6115 Maple Street, Omaha, NE

| PROJECT NAME: INFUSION BREWERY | | AD2.1 | |
| PROJECT NUMBER: 12092 | | ADDENDUM #2 | |

ADDENDUM #2

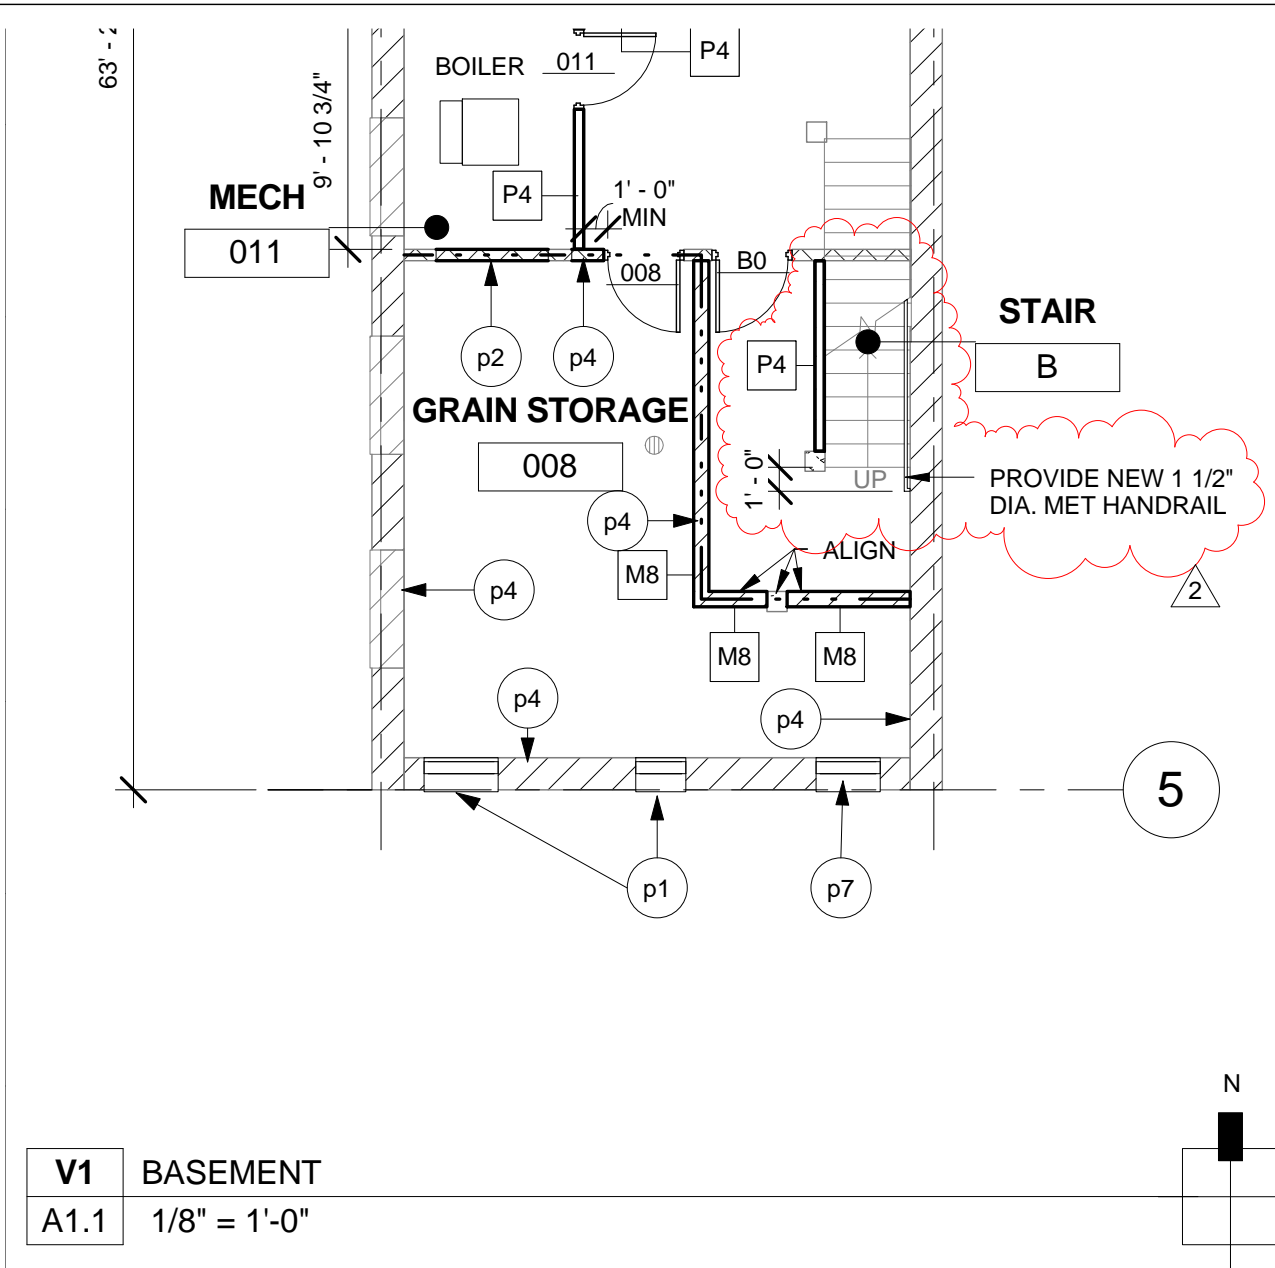
1. SUPPLEMENTAL DRAWING AD2.1 - SHEET 1.1 –
 - a. Add P4 wall between existing column and wall at edge of stair.
 - b. Add 1 ½" dia. Metal handrail to east wall. Extend 12" from bottom step and 23" from top step.
2. SUPPLEMENTAL DRAWING AD2.2 – SHEET A2.1 –
 - a. Delete note to provide new face brick. Remove face of brick column. Provide new brick to match historic color and texture.
3. SUPPLEMENTAL DRAWING AD2.3 - SHEET A5.1 –
 - a. At West Wall of Women's Toilet - Fur out with Wall Type F2. Finish to match other Toilet Walls.
 - b. Eliminate M8 infill at Women's Toilet windows. Existing wood window to remain. Repair and paint exterior frame. Existing CMU on interior side of windows to remain.

V8 BASEMENT MECHANICAL
M2.1 1/8" = 1'-0"

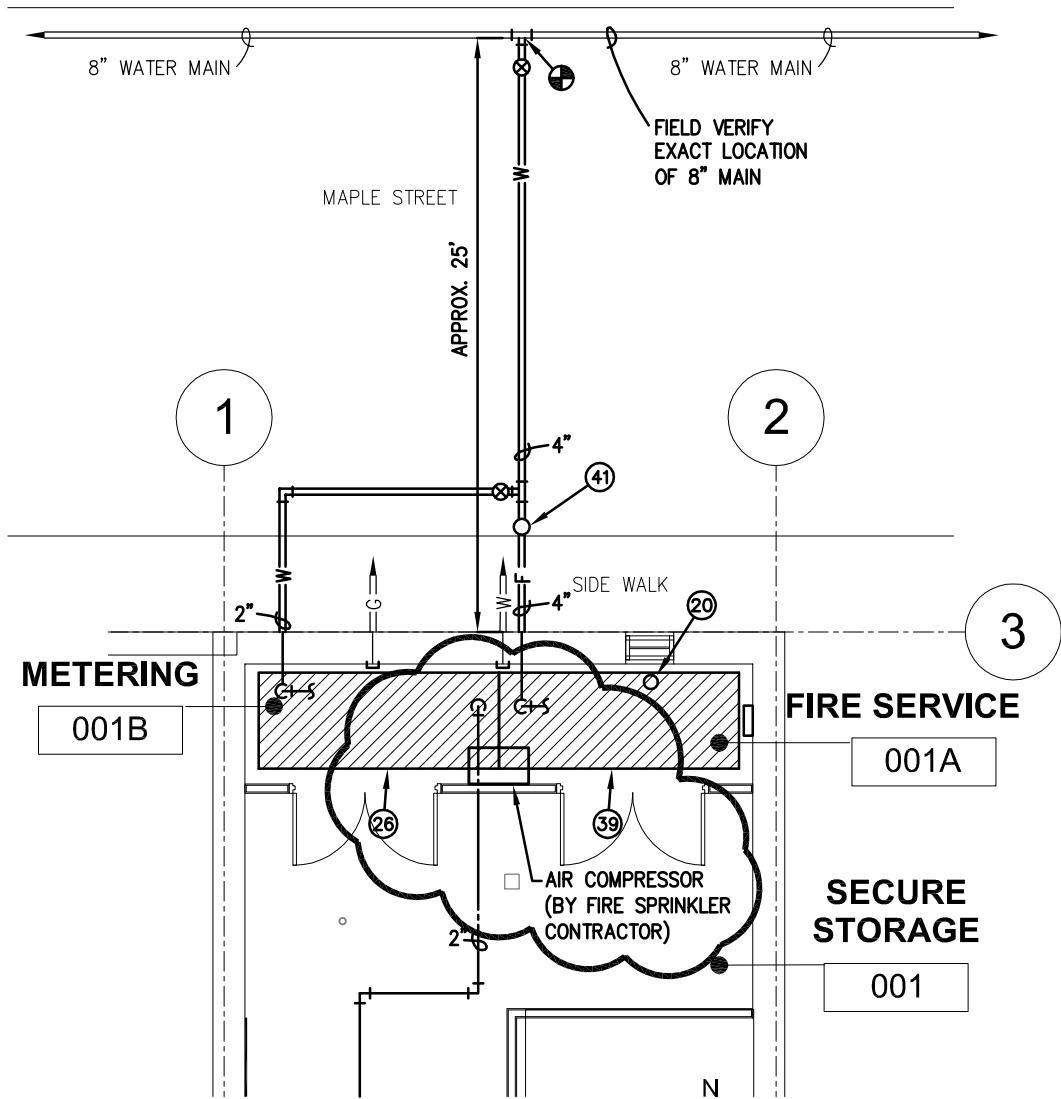
- a. See drawing M1, Basement Mechanical, Fire Service Room 001A, for addition of air compressor. Sheet note 39 shall point to fire service on East side, and sheet note 26 shall point to water service on West side.

| V1 | MECHANICAL ROOF PLAN |

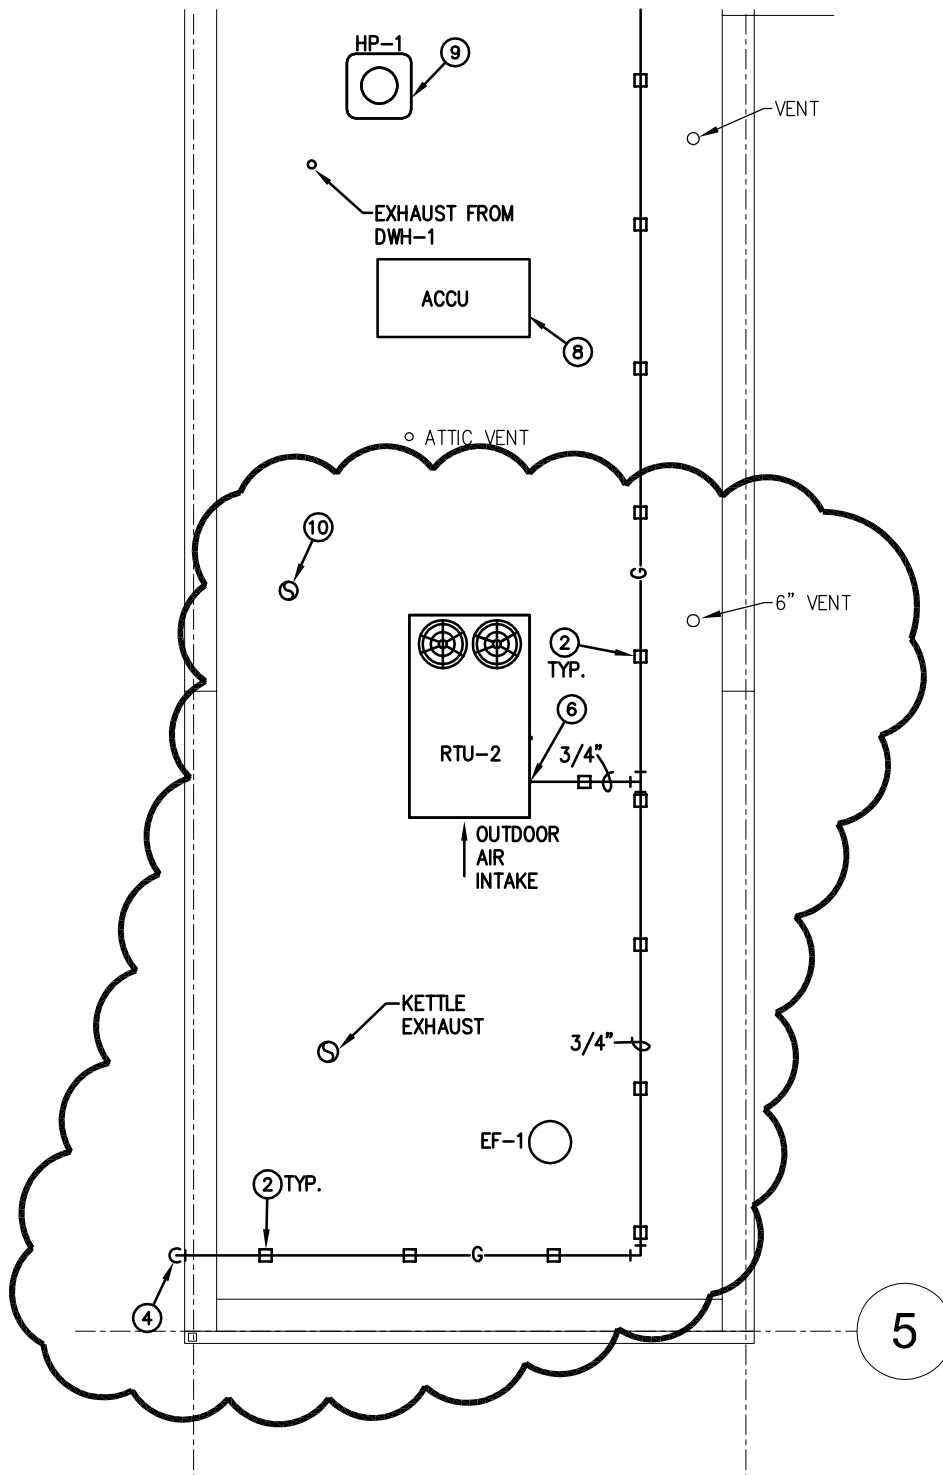
2. Sheet M2.2 Enlarged Mechanical Plans and Risers
 - a. See drawing M2, mechanical Roof Plan, for adjusted location of RTI-2 and the boiler flue termination. Also see new location of kettle exhaust termination through roof and EF-1, now an upblast fan located on roof. RTI-2 outdoor air intake must be a minimum of 10' away from all exhaust outlets per Mechanical Code.

| V1 | BASEMENT HVAC |

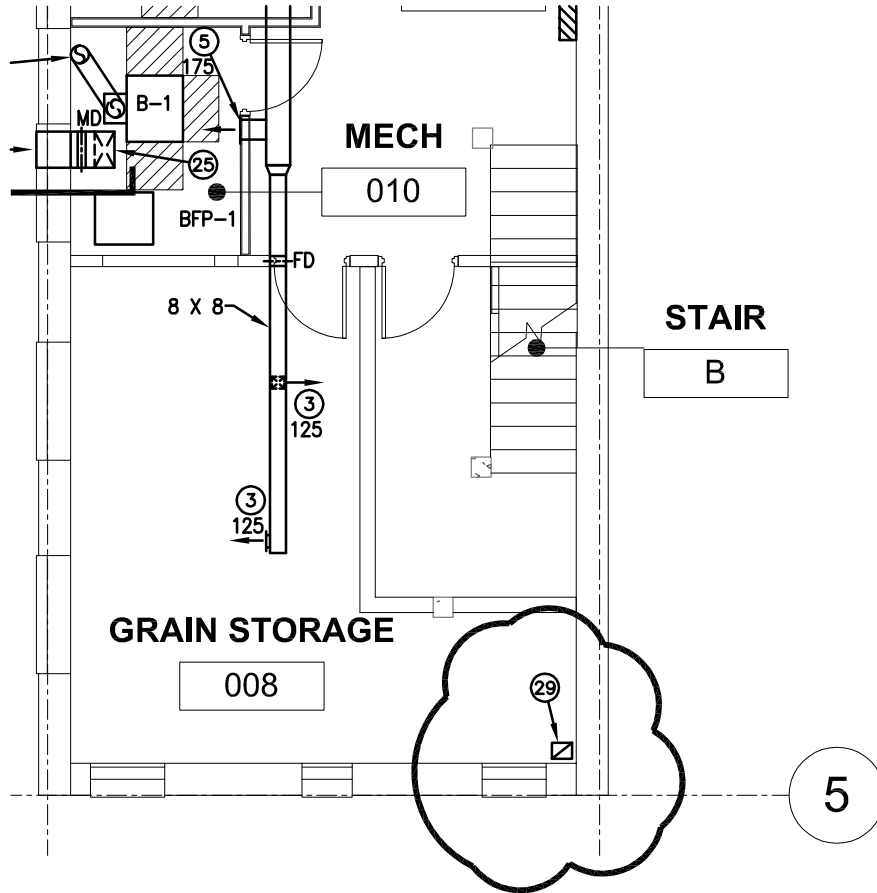
3. Sheet M3.1 HVAC Plans
 - a. See drawing M3 and M4 for adjusted HVAC in Grain Storage 008 and Brewery 107. Exhaust from Grain Storage shall now be routed through Brewery to roof top mounted fan. Exhaust from the kettles shall now terminate through roof. Boiler flue shall now elbow to East to provide clearance from exterior wall.

- 29. 10 X 8 EXHAUST DUCT UP. DUCT SHALL BE OPEN ENDED, AND INSTALLED AS HIGH AS POSSIBLE. COORDINATE DUCT PENETRATION LOCATION WITH GRAIN AUGER. PROVIDE FIRE DAMPER AT CEILING PENETRATION. PROVIDE 8 X 8 FIELD FABRICATED ACCESS DOOR IF DAMPER IS UNABLE TO BE RE-SET AT OPENING..

| V9 | MAIN LEVEL - HVAC |

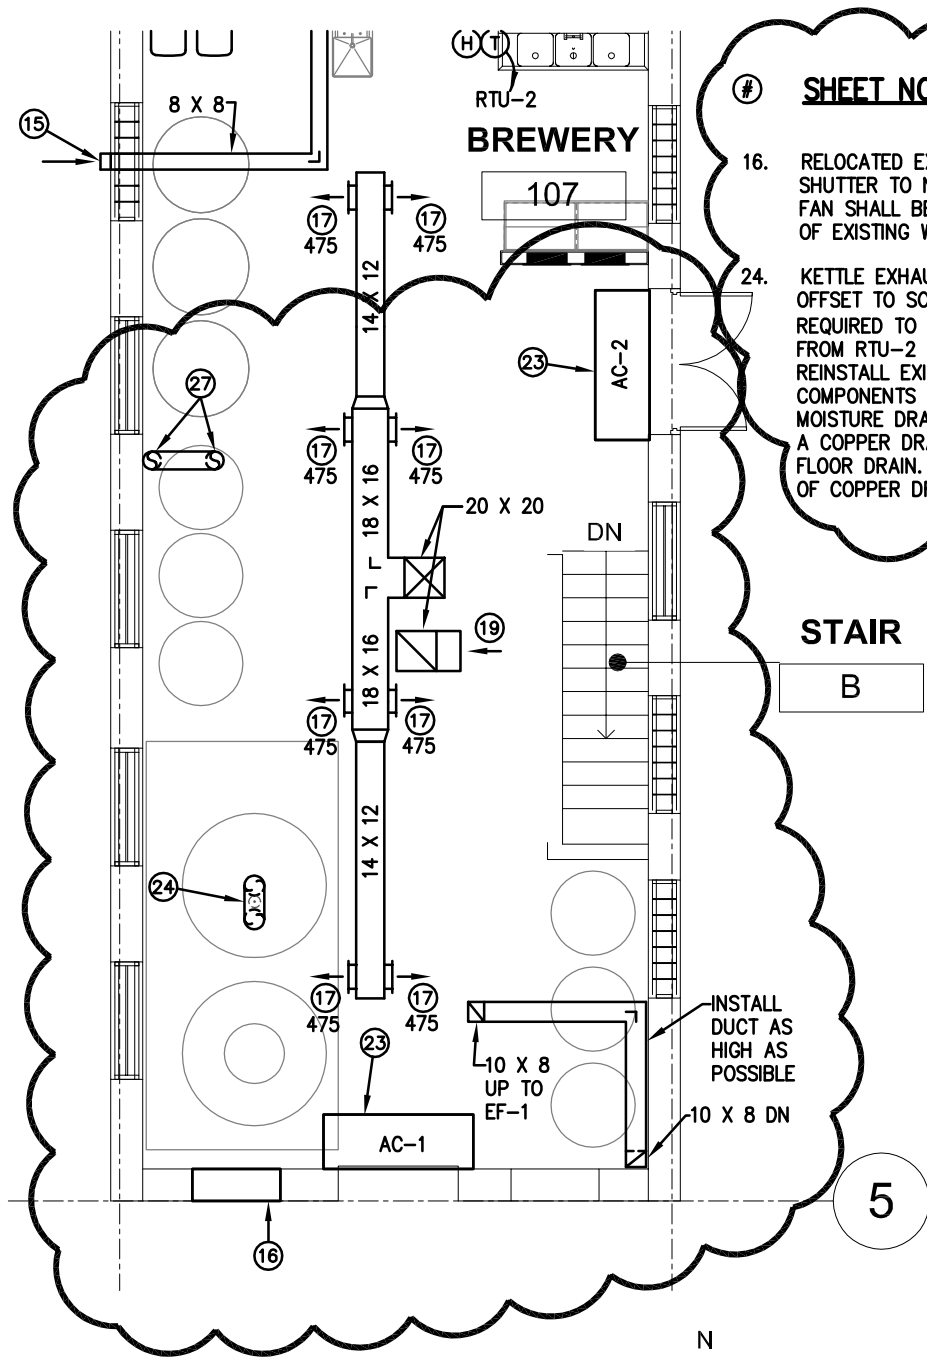
- # SHEET NOTES**
- RELOCATED EXISTING EXHAUST WALL FAN AND SHUTTER TO NEW LOCATION AS SHOWN. WALL FAN SHALL BE INSTALLED TIGHT TO THE BOTTOM OF EXISTING WINDOW OPENING.
 - KETTLE EXHAUST THROUGH ROOF, PROVIDE OFFSET TO SOUTH INSIDE BREWERY AS REQUIRED TO KEEP MINIMUM 10'-0" DISTANCE FROM RTU-2 OUTDOOR AIR INTAKE ON ROOF. REINSTALL EXISTING VENT PIPING AND ALL COMPONENTS AS SHOWN, SLOPE PIPE BACK TO MOISTURE DRAIN. MOISTURE DRAIN SHALL HAVE A COPPER DRAIN LINE ROUTED TO NEAREST FLOOR DRAIN. SEE SHEET M2.1 FOR ROUTING OF COPPER DRAIN LINE.

| L22 | FIRE SERVICE DETAIL |

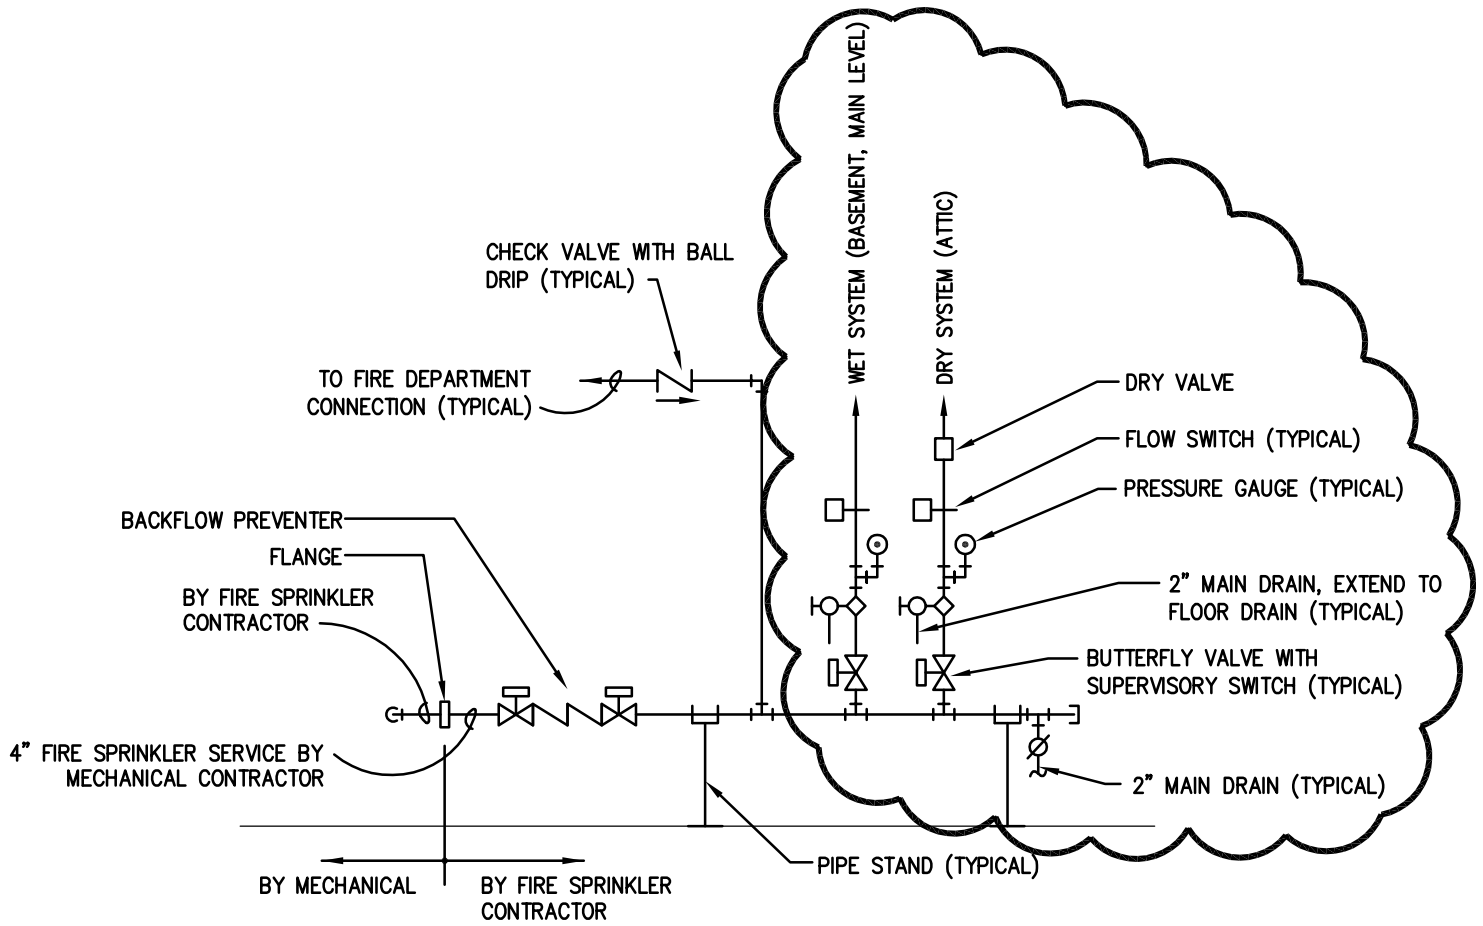
4. Sheet M4.1 Mechanical Details
 - a. Detail E24 – Exhaust Fan (EF-1) Detail shall now be omitted from plans.
 - b. See drawing M5, Fire Service Detail L22 shall now have a Dry System zone added.
